# Access Compliance Report

## Public Rights-of-Way

### (Curb Ramps)

Intersection ID: 53746	Main Street: SPRINGWOOD_ESTATE_DR	Cross Street: CANTERBURY_CASTLE_DR	Location: NE
ADA ID: FFD64A6609CB	Ramp Type: Perp	Initial Pass/Fail: Fail	Overall Compliance: No
Severity Score: 33.75			
Codes/Mitigation Info/Possible Solution		Field Measurements/Component Compliance

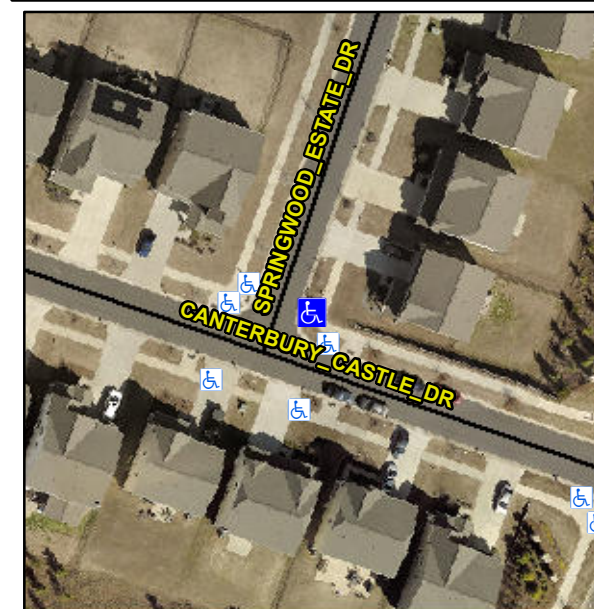
**Not Found, R304.5.1, R304.2.2, R304.5.3**

Compliance	Description	Data	Compliance	Description	Data
N/A	Ramp Length (in)	103.0	No	Ramp Slope (%)	9.0
No	Ramp Width (in)	45.5	No	Ramp XSlope (%)	5.9
N/A	Flare Type LT	N/A	N/A	Flare Type RT	N/A
N/A	Flare Slope LT (%)	N/A	N/A	Flare Slope RT (%)	N/A
N/A	Flare Traversable LT?	N/A	N/A	Flare Traversable RT?	N/A
N/A	Landing Length (in)	N/A	N/A	DWS Provided?	N/A
N/A	Landing Width (in)	N/A	N/A	DWS Contrast?	N/A
N/A	Landing Slope (%)	N/A	N/A	DWS Length (in)	N/A
N/A	Landing X Slope (%)	N/A	N/A	DWS Full Width?	N/A
N/A	Landing Curb? (Y/N)	N/A	N/A	DWS Offset (in)	N/A
N/A	Shared Landing?	N/A			
N/A	Gutter Ponding?	N/A	N/A	Gutter Slope (%)	N/A
N/A	Gutter Lip Ht (in)	N/A	N/A	Gutter X Slope (%)	N/A
N/A	Painted X Walk1?	No	N/A	Painted X Walk2?	N/A
	X Walk 1 Direction	To NW		X Walk 2 Direction	N/A
N/A	X Walk 1 Width (in)	N/A	N/A	X Walk 2 Width (in)	N/A
	X Walk 1 Slope (%)	0.5		X Walk 2 Slope (%)	N/A
	X Walk 1 X Slope (%)	6.9		X Walk 2 X Slope (%)	N/A

**Remove & Replace Entire Ramp.**
